DALTON LAKE DAM

STE. GENEVIEVE COUNTY, MISSOURI

PHASE 1 INSPECTION REPORT NATIONAL DAM SAFETY PROGRAM

SUBJECT: Dalton Lake Dam Phase I Inspection Report

DALTON LAKE
DAM & SPILLWAY PROFILES
 Horner & Shifrin, Inc. Oct. 1978

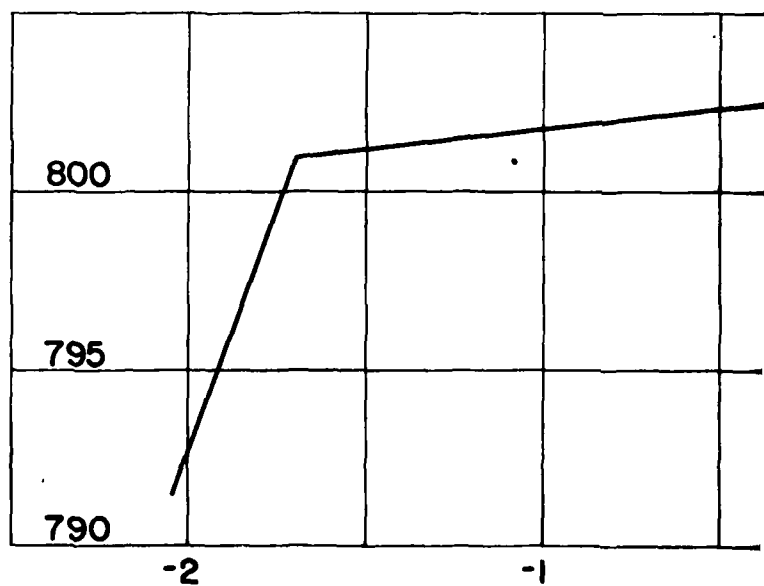
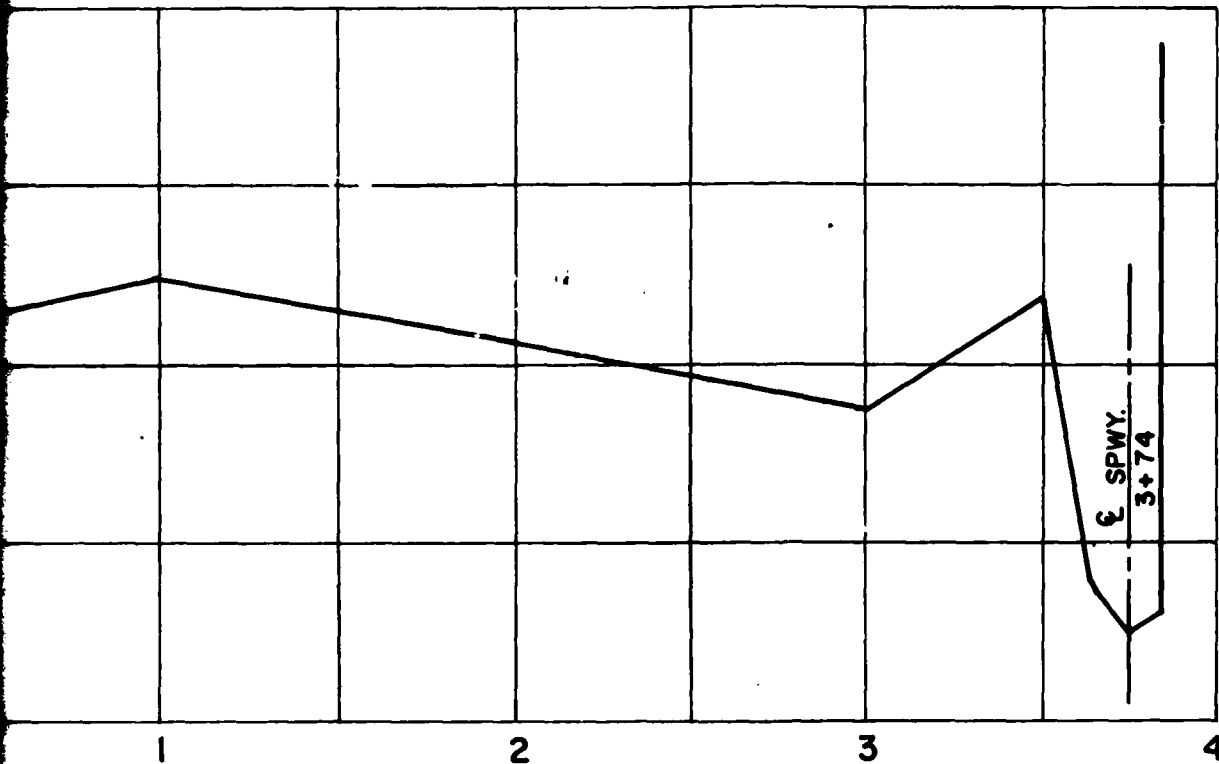
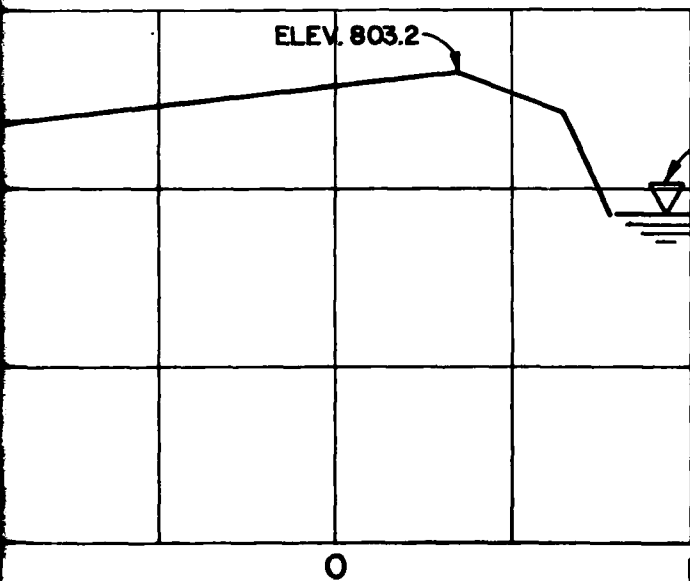
The crest of the dam was found to be approximately 2 feet lower near the left abutment than in the area adjacent to the spillway. (The low point of the dam is approximately 2 feet higher than the spillway crest.) As a result, the capacity of the spillway to discharge lake outflow without overtopping the dam is reduced.

(5) The top of the dam is approximately 2 feet lower near the left abutment than the top of the dam at the spillway.

(2) It is recommended that the low area on the top of dam located near the left abutment be raised such that it will not limit the spillway capacity. Since it is possible that the low area is a result of settlement due to consolidation of the embankment and foundations soils, and since it is not known if all or nearly all of the settlement that is probable has taken place (the dam is about 4 years old), it is recommended that future settlement of the dam be monitored in order to determine overtopping potential and conditions affecting the operation of the spillway.
